**APPLICATION NUMBER 17/P/5545/OUT**

**C AND M SANDERS**

**REVIEW OF NORTH SOMERSET D&E HIGHWAYS AND TRANSPORT  
MEMORANDUM**

Figure 3.1  
Proposed Access  
Arrangement and  
Visibility on Bridgwater  
Road.

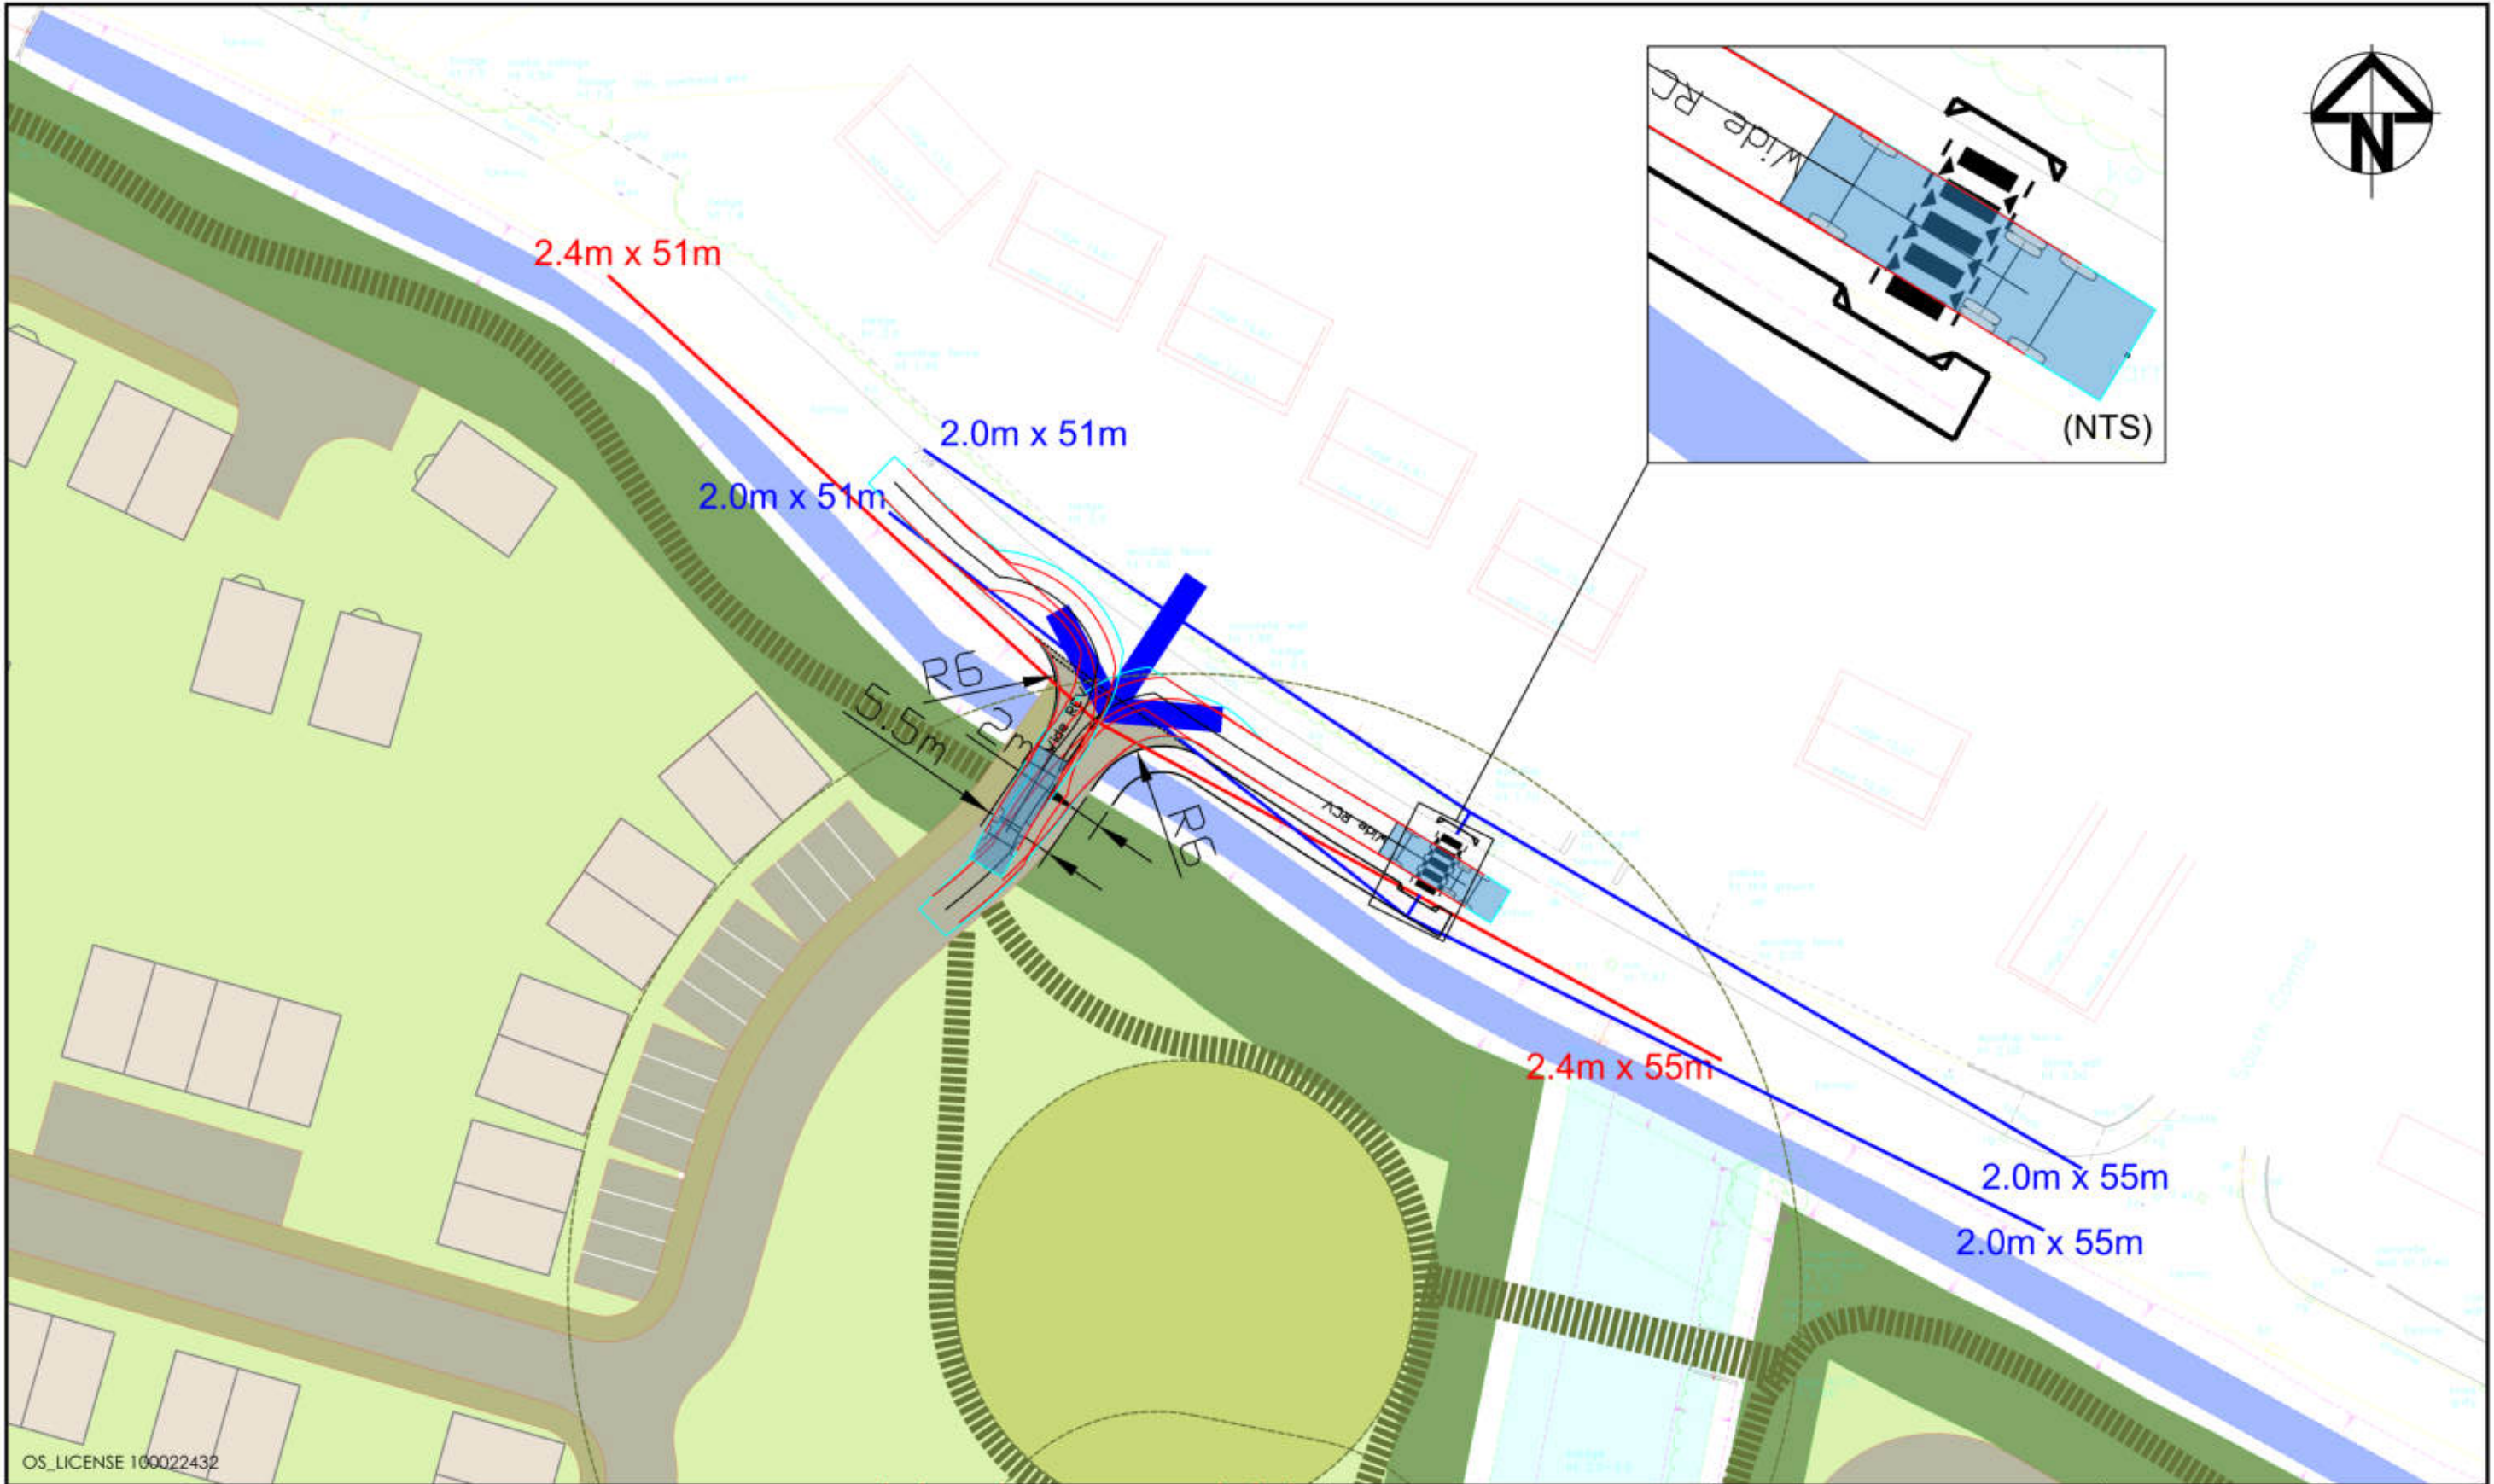
2.1 The LHA’s response suggests that “...**a minimum visibility splay of 215 metres would be required.**” Whilst it is accepted that the location of the proposed site access is within an area of 60mph speed limit it is also noted that the visibility splay to the right for vehicles leaving the site (ie towards the north) extends into the adjacent 50mph speed limit. It is reasonable to conclude therefore that in regard specifically to the splay to the right, a more appropriate comparator would be the splay specified for a 50mph design speed, equating to 160m.

2.2 Notwithstanding the above, the Council’s response suggests that the TA “...failed to demonstrate achieved visibility splays...”, however, Paragraph 3.2 of the original TA stated;

2.3 It is accepted that the above visibility splays were not illustrated on a plan, however, the dimensions were clearly set out in the report’s text and no suggestion has been made by officers that these stated observations are in any way inaccurate. Indeed, if officers have visited the site (and this is unclear from the responses to date), they would have seen that the verge is extremely wide along the site’s A370 frontage. The frontage is largely straight, leading to substantial visibility in both directions, as illustrated in the photographs below.

**“3.2 cTc has measured on-site the available visibility from the proposed site main access on the A370. This is:**

- **To the left (towards westbound traffic) 2.4m x 294m; and,**
- **To the right (towards eastbound traffic) 2.4m x 290m.”**

- 2.4 It is clear that the TA did contain confirmation that visibility splays in excess of 215m 'y' distance stated in the response are available from the location of the site access. Moreover, the more appropriate DMRB figure of 160m, for a 50mph speed limit as applies at the extent of visibility to the north is even more substantially exceeded by the visibility available on the ground.

- 2.8 It is very clear from the above that safe visibility splays are available at the location of the proposed site access and that this was clear from the discussions in the TA.

Figure 5.1  
Proposed Northern  
Access Arrangement on  
Bleadon Road.

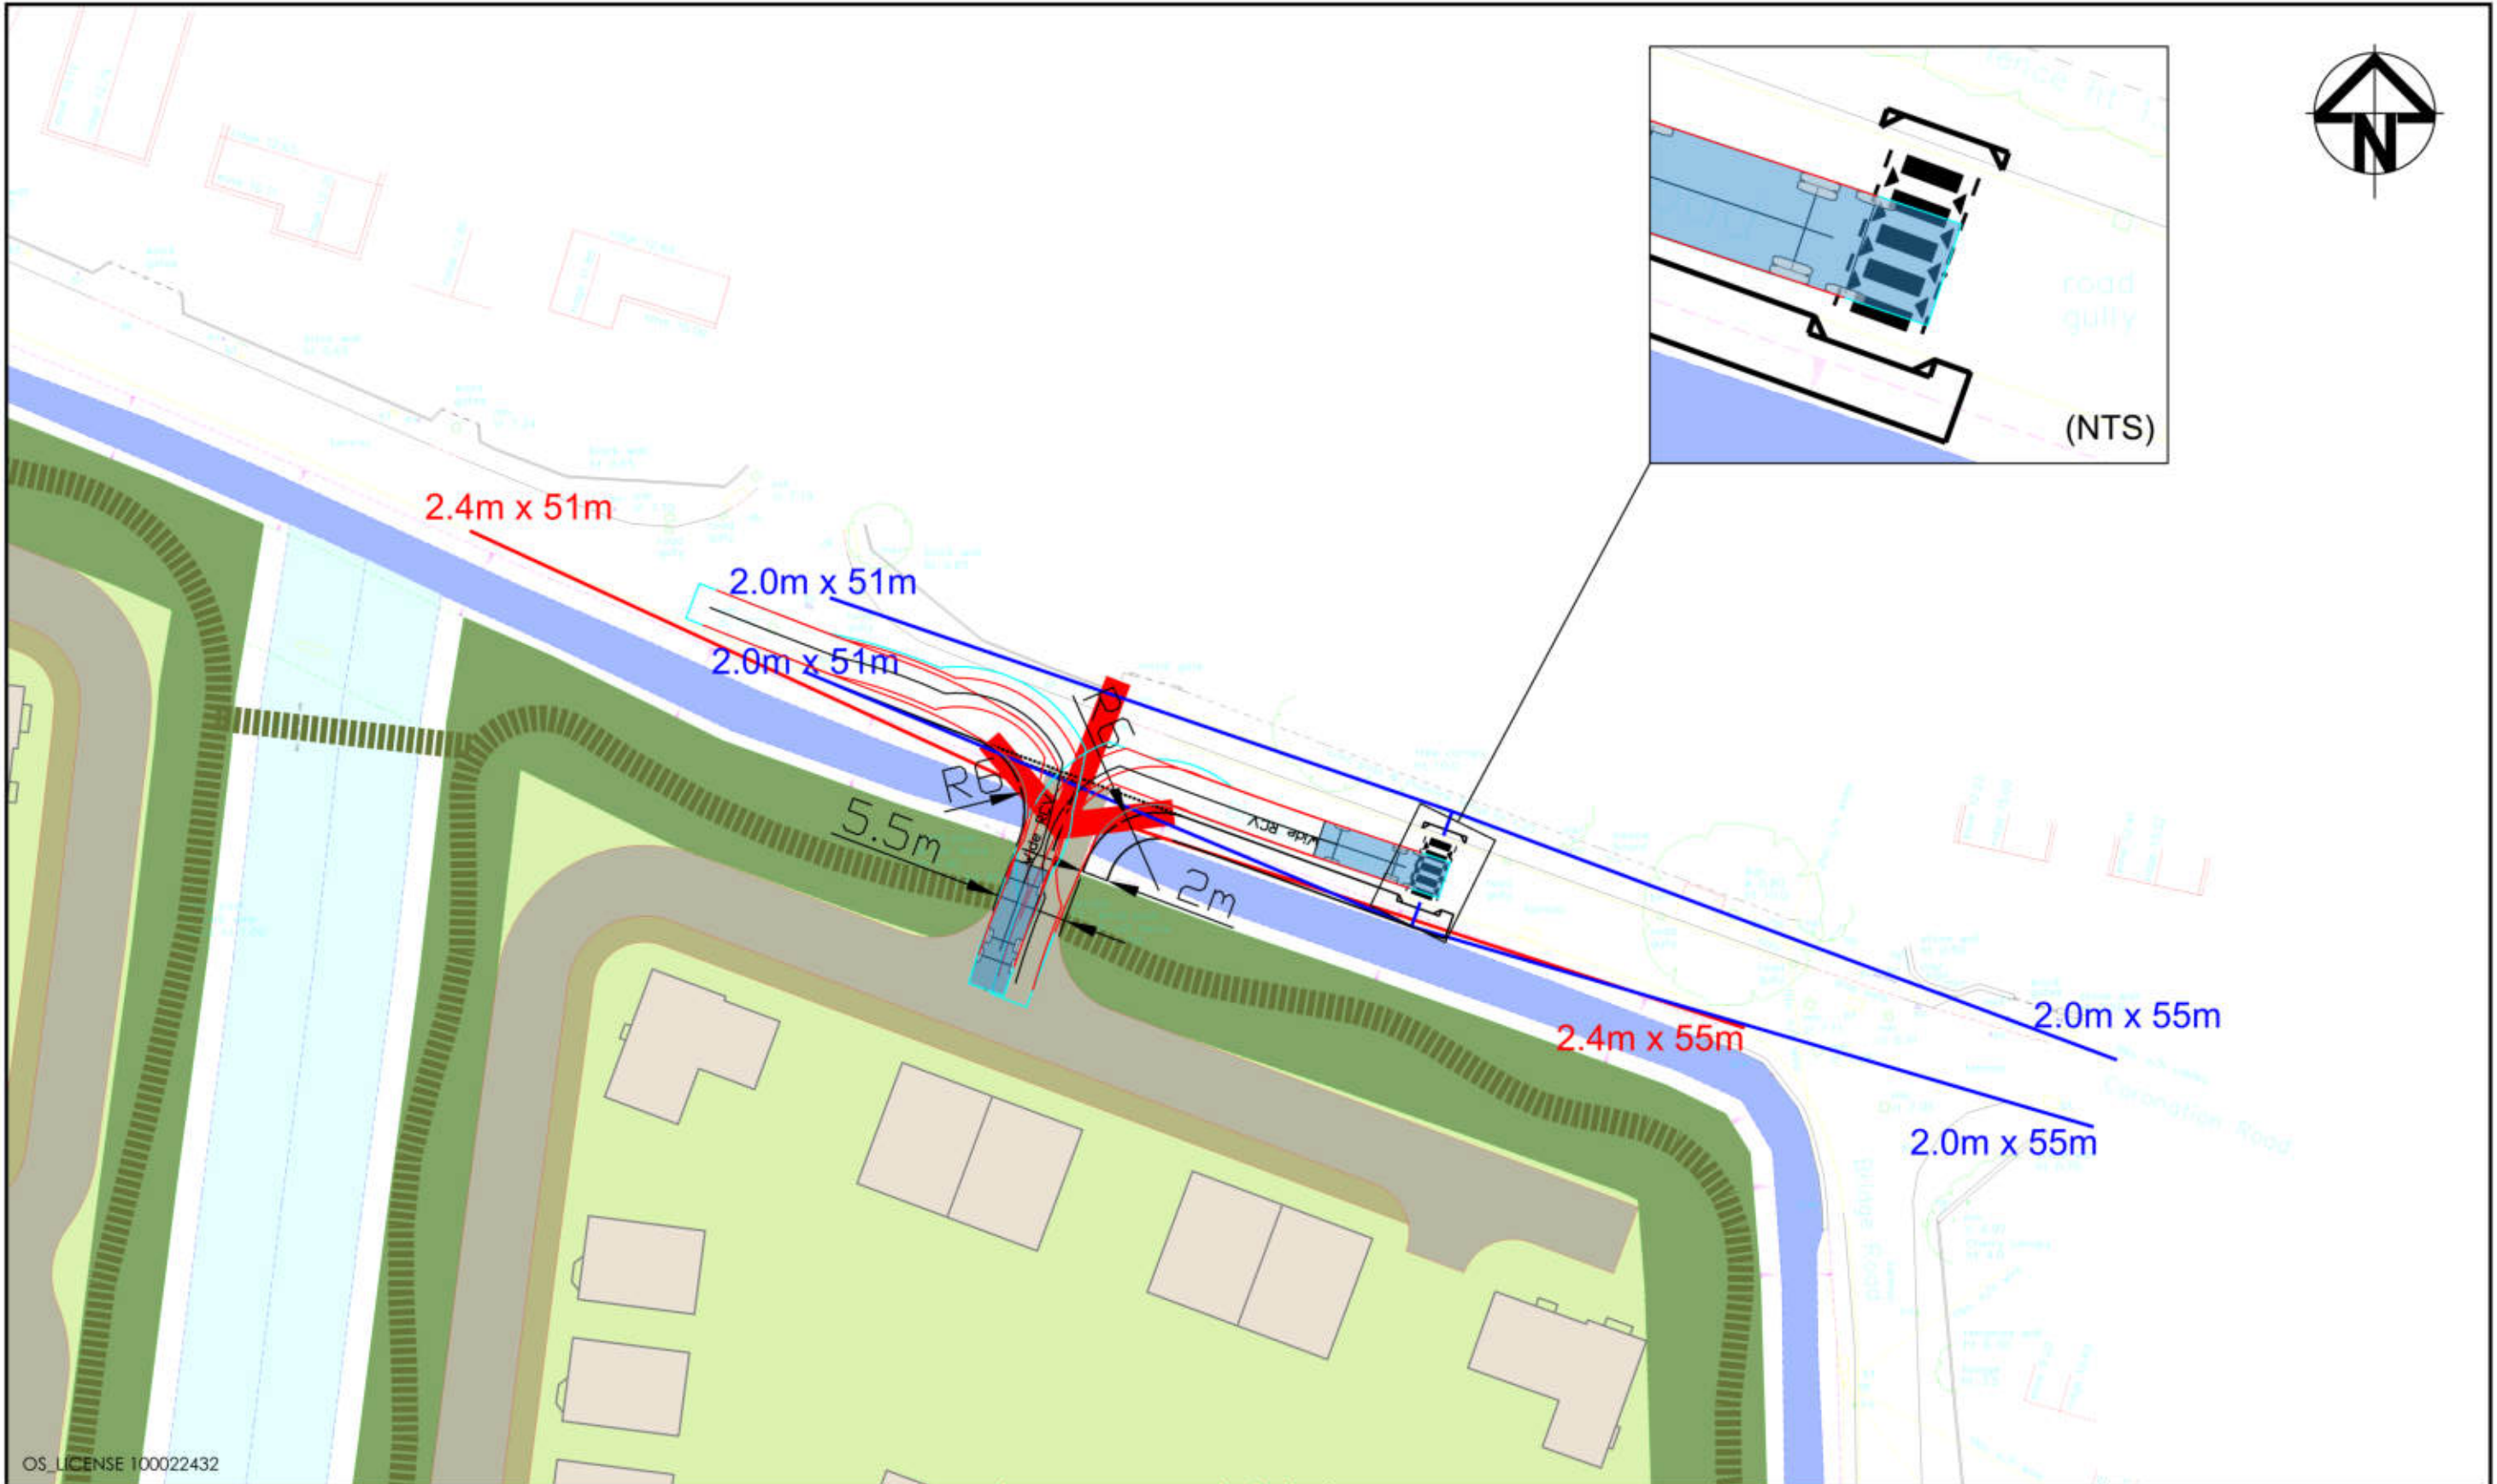
- 2.17 The response confirms that the visibility splays specified are appropriate for an access junction in this location.
- 2.18 Subsequently, it is identified that TA91/05 suggests that “**...zebra crossings should not be introduced on roads with an 85<sup>th</sup> percentile speed of 35mph or more.**” This is indeed an accurate quote from TA91/05 (Para 6.32), however, it should be considered in context with the LHA's other request(s) in regard to these proposals. Two paragraphs earlier in the Consultation Response it is stated that “**Current speeds are in excess of the speed limit and this issue would need to be addressed.**”

2.19 Consequently, it is acknowledged that existing speeds are above the recommended maximum for providing a zebra crossing by some 0.6mph in a westbound direction. In an eastbound direction they are 1.4mph below this limit. The proposals comprise not simply a zebra crossing but a flat-top, raised area upon which the crossing will sit. In combination with a second similar facility further south and signage as appropriate (to be agreed with the LHA) this is intended to significantly reduce vehicle speeds on this route. It is likely in any case that simply providing housing on the site, forming the western boundary to the highway will change the perception of drivers and consequently it is considered unlikely that traffic speeds would remain above the specified 35mph even in the absence of additional control measures. Considering the proposal to raise the crossings onto flat top, table-designs, traffic speeds will very clearly drop by a material amount and zebra crossings are certainly appropriate in this instance.
